## Product Change Notice (PCN)

PCN Number: PCN-0374215R-01

### Product(s) Affected: CEM-14R06CT

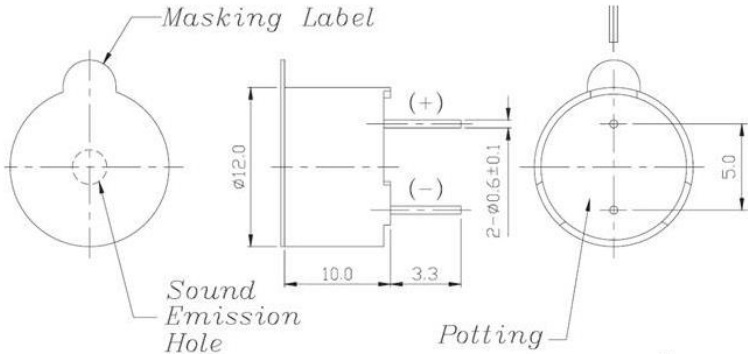
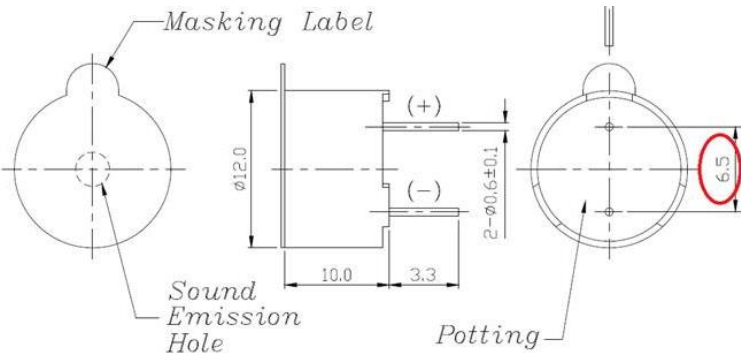
Reason(s) for Change:  
Due to PCB Shortages and excessive lead times. CUI Devices will be changing the PCB and will only affect the pin Pitch from 5mm to 6.5mm

- Pin Pitch from 5mm to 6.5mm
